GRUMMAN AIRCRAFT ENGRG CORP
BETHPAGE, L.I., N.Y.

SHUTTLE BOOSTER SAY-AR14 TANK SUPT

GRUMMAN AIRCRAFT ENGINEERING CORP.
CODE IDENT NO. 26512
ENGINEERING ORDER

DRAWING TITLE: STRUTS ASCENT STAGE-SHIELD TRUSS

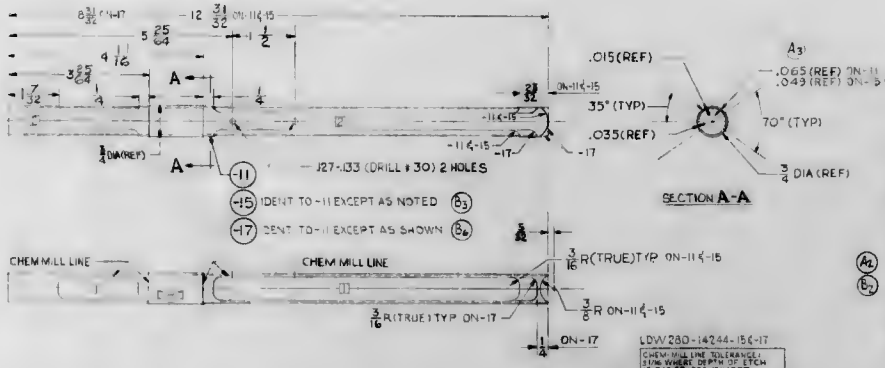
ON THE FOLLOWING DRAWING DETAILS REVISE
CHEM-MILL TOLERANCE ±.887 WAS ±.003 ±.002

PROVIDE MORE REALISTIC TOLERANCE.

DESCRIPTION OF EO
FOR - * REVISE
CHEM-MILL TOL. ±.005 ±.001 WAS ±.003 ±.002

DRAWING NO	DASH NO	CHANGE NO.	EFFECTIVITY
LDW280-14274	-11-13	B2	LTA-3(13) LM-3(33) THRU LM-6(36)
LDW280-14330	-11-13	B3	LTA-3(13) LTA-8(18) LM-1(31) THRU LM-3(33)
LDW280-14331	-11-13	B6	
LDW280-14332	-11	C1	
LDW280-14333	-11	B4	
LDW280-14334	-11 THRU -17	B3	
LDW280-14335	-19	B2	
LDW280-14336	-11	B2	LTA-3(13) LTA-8(18) LM-1(31) THRU LM-3(33)
LDW280-14343	-11 THRU-21	C1	LTA-3(13) LM-3(33) THRU LM-15(45)
LDW280-14347	-11 THRU-21	B1	LTA-3(13) LM-3(33) THRU LM-15(45)
LDW280-14348	-11 THRU-17	B1	LTA-3(13) LM-3(33) THRU LM-15(45)
